REQUEST Current Zoning: R-3 LWPA (single family residential, Lake Wylie

Proposed Zoning: NS LWPA (neighborhood services, Lake Wylie

The petition proposes to allow 46,000 square feet of office and commercial uses on a parcel developed with a single family residential home in Northwest Charlotte.

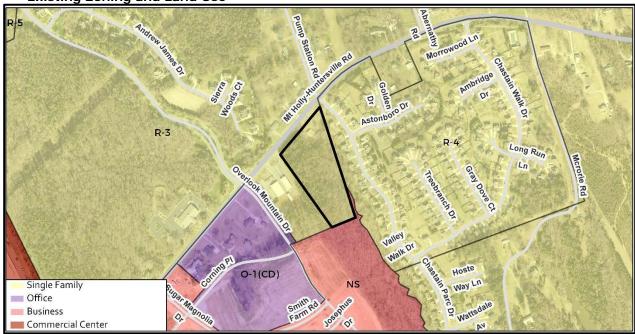
- Up to 46,000 square feet of commercial/office uses. Limits the amount of retail uses to 8,000 square feet.
- Prohibits the following uses: jails and prisons; drive-through service windows associated with eating, drinking and entertainment (EDEE) establishments; automobile service stations; automotive repair garages; car washes; tattoo establishments; adult establishments; cemeteries; crematoriums; and outdoor storage.
- Illustrates Building Envelopes A and B and parking envelope.
- Maximum building height of 45 feet.
- Minimum 32-foot Class C buffer along the site's eastern property line along with a 6-foot tall opaque fence.
- Illustrates existing 30-foot stream buffer along a portion of the eastern property line.
